Work Order ID 146592

Item Name: Replacement Skidtube (Fits LH or RH)

DRAWING NO. D2650	TITLE 206/407 SKIDTUBE ASSEMBLIES	REV. F	DART AEROSPACE LTD ENGINEERING ORDER		D.E.O. NO. D2650-F-1	SHEET NO. SHEET 1 OF 1	SCALE NTS
DRAWN <i>[Signature]</i>	CHECKED A.P.	MFG. APPR. <i>[Signature]</i>	APPROVED <i>[Signature]</i>		DE APPR. <i>[Signature]</i>		
DATE 12.10.12	DATE 12.10.22	DATE 12.10.22	DATE 12.10.22		DATE 12.10.22

CHANGE C'BORED WELDED CROSSBOLT SPACERS TO SWAGED SPACERS

AMENDMENT TO DETAIL B
NOT TO SCALE

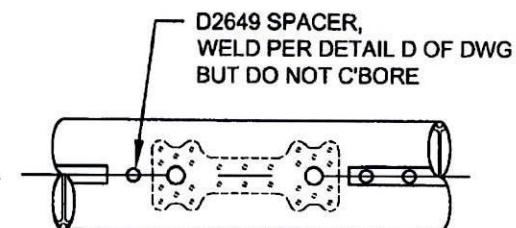
ADD DETAIL G BELOW, WHICH IS THE SAME SECTION VIEW AS DETAIL D OF DWG.
C'BORED HOLES ARE **NOW SWAGED** PER DETAIL G BELOW. FOR THE Ø0.375 HOLE THAT IS NOT C'BORED, WELD PER DETAIL D OF DWG (SEE AMENDED DETAIL B FOR REFERENCE).

DETAIL G

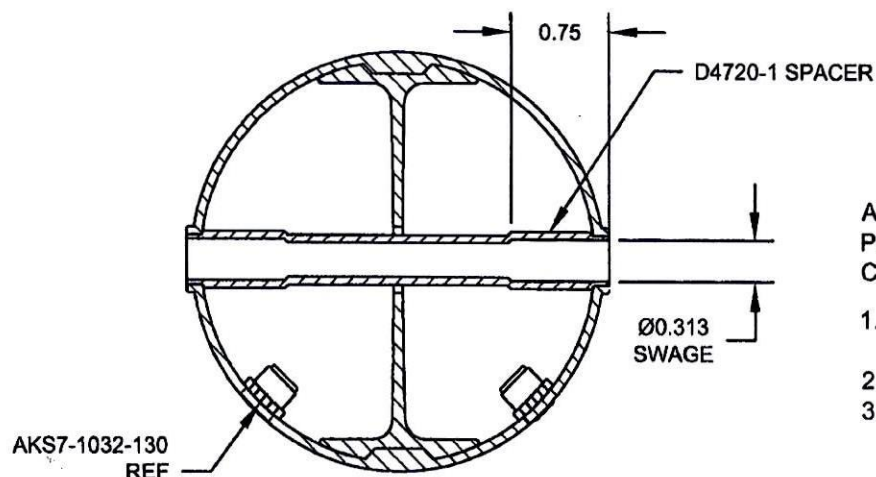
AFTER DRILLING AND BENDING ASSEMBLY
PERFORM THE FOLLOWING FOR Ø0.375 HOLES THAT ARE
CURRENTLY C'BORED:

1. INSERT D4720-1 SPACER, 16 PL (-1) OR 17 PL (-3)
OR 19 PL (-5) OR 23 PL (-7)
2. SWAGE TO Ø0.313 X 0.75 DP PER QSI 002
3. TRIM / GRIND FLUSH PER QSI 002
